RE: Response to Technical Evaluation Comments and Information Request  
for Underground Injection Control (UIC) Permit Application  
Class VI Pre-Construction Permit Application No. R9UIC-CA6-FY20-1

### Site Characterization Evaluation of the CES-Mendota Class VI Permit Application

Figure 47: Potentiometric map of the approximate shallowest groundwater surface

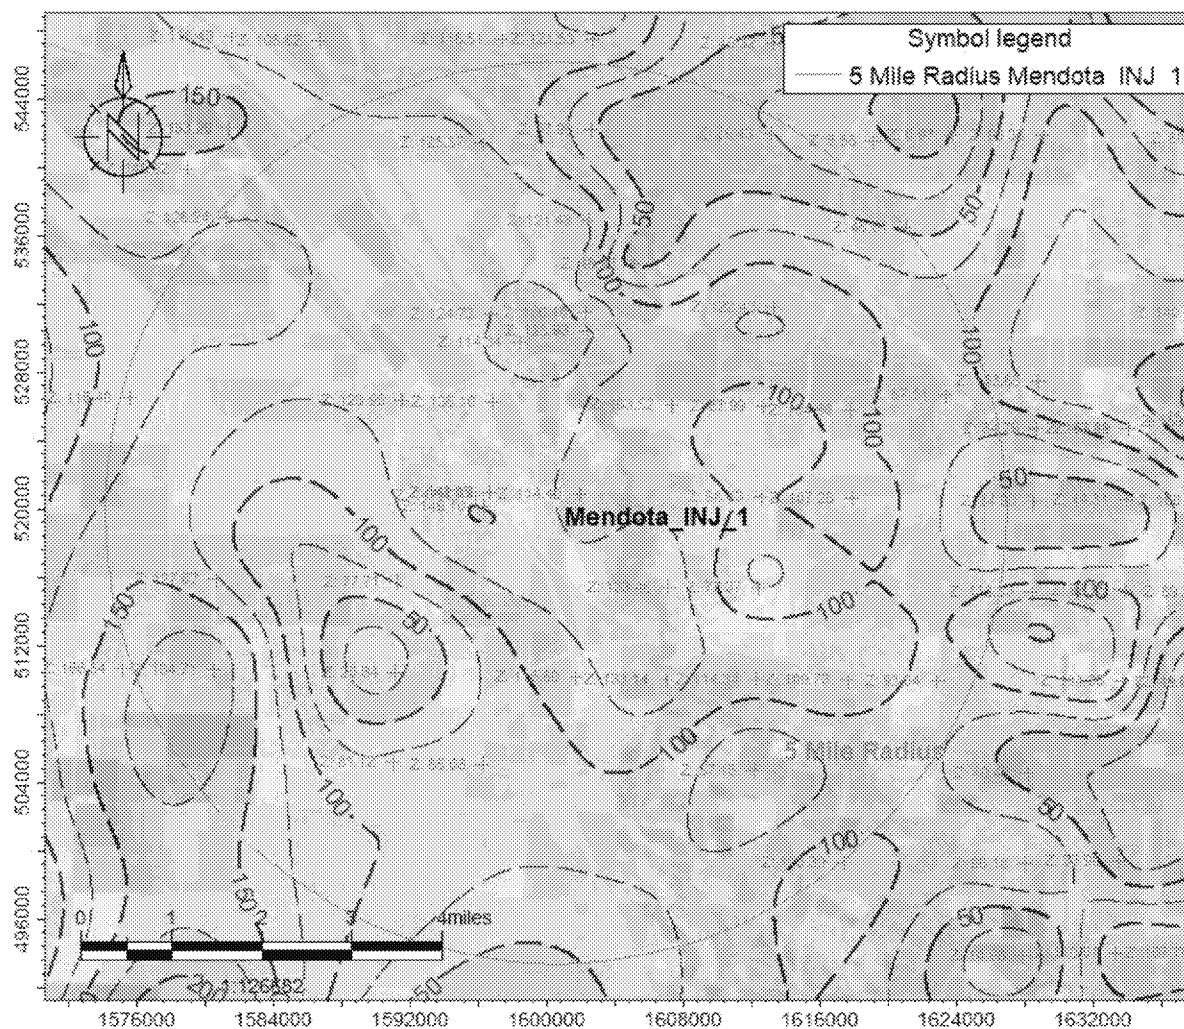
- *Please provide a legend or labeled contours for the potentiometric map in Figure 47.*
- *Figure 47: Potentiometric map of the approximate shallowest groundwater surface was updated with labeled contours. Please refer to Appendix A.*

Figure 46: Water well and surface water

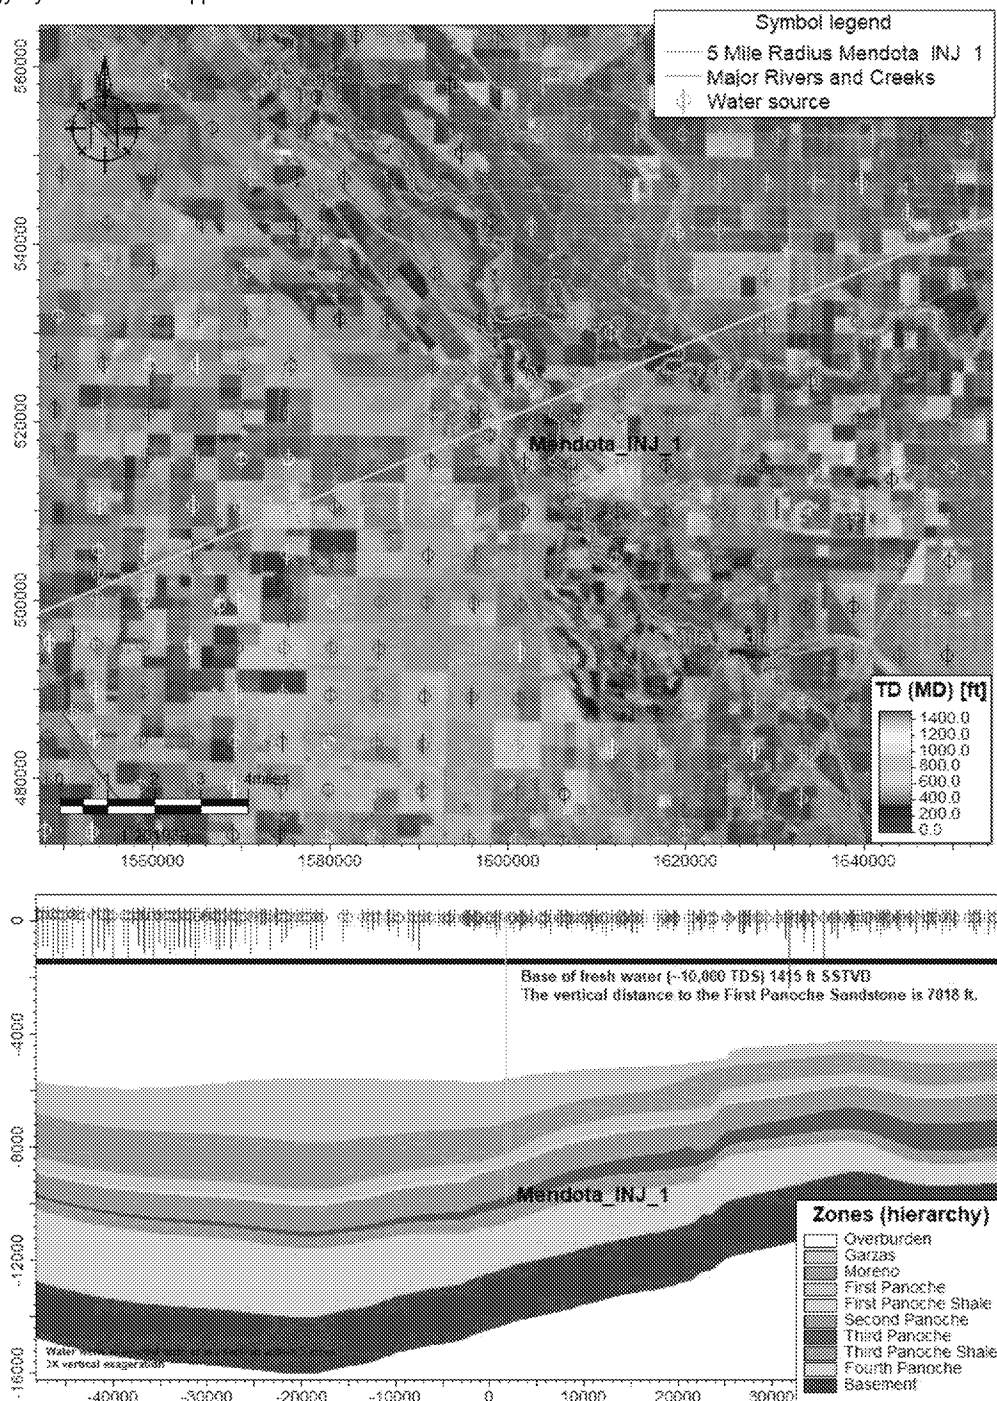
- *What is the vertical distance between the First Panoche Sands and the lowermost USDW?*
- *At the proposed injection well location, Mendota\_INJ\_1, the vertical distance from the First Panoche Sandstone to the calculated lowermost USDW (1,415 TVDSS) (10,000 TDS) is 7,018 ft. This clarification was added to Figure 46. Please refer to Appendix A: Updated Figures.*

- *Figure 46 includes a line marking the base of fresh water at 10,000 TDS. Section 2.7.1 of the application narrative discusses a BFW of 3,000 mg/L. Please confirm that no evaluations of the lowermost USDW are based on a definition of 3,000 mg/L.*

- *The lowermost USDW in this application always refers to the 10,000 TDS limit. The California regulations of 3,000 mg/l (base of fresh water) was used as a quality control check when reviewing well reports.*
